MECKLENBURG COUNTY HEALTH DEPARTMENT

APPLICATION FOR PERCOLATION TEST

SITE DISAPPROVAL REPORT
INDIVIDUAL SEPTIC TANK SYSTEM WITH SUBSURFACE, SOIL ABSORPTION, EFFLUENT DISCHARGE

SUBJECT: APT #7247 (Ralph Squires Construction Co.)
Lot No. 5-F 13500 Andulusian Drive
Windrow Estates Subdivision

7) ACCURATELY DIAGRAM & DIMENSION LOT

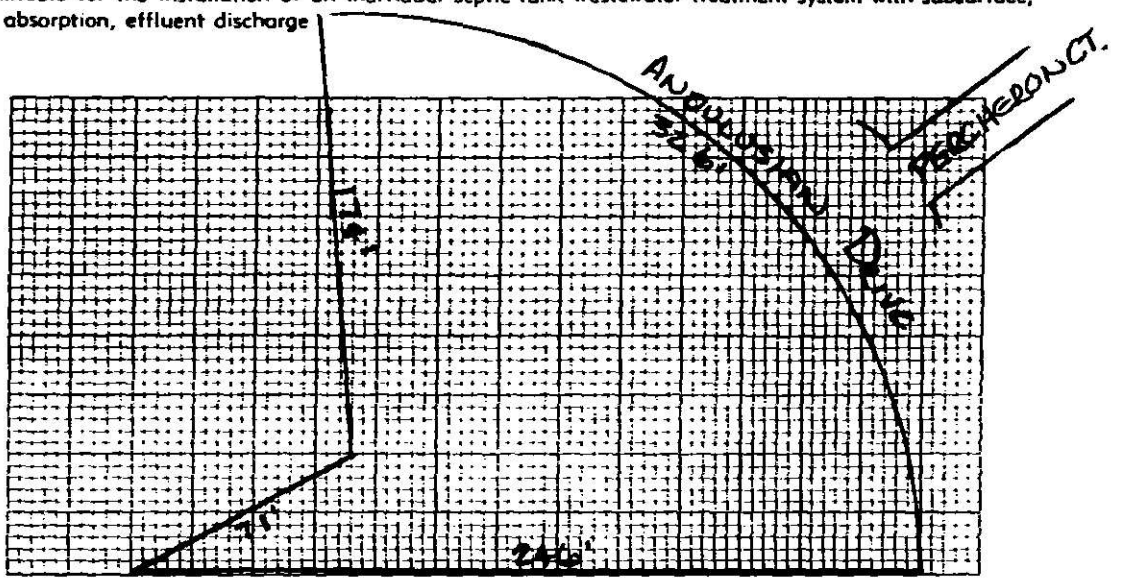
X ON SITE INSPECTION REVEALED LOT TO BE UNSUITABLE FOR THE FOLLOWING REASON(S) 4-1-74 - Soils over the majority of the lot are of the Chewacla series. These soils have a seasonal high water table within 18 inches of the soil surface and are subject to flooding. These soil characteristics result in inadequately slow permeability and percolation rate.

Soils over the majority of the lot are of the Chewacla series. These soils have a seasonal high water table within 18 inches of the soil surface and are subject to flooding. These soil characteristics result in inadequately slow permeability and percolation rate.

Based on this investigation, the lot appears unsuitable for installation of a septic tank system.
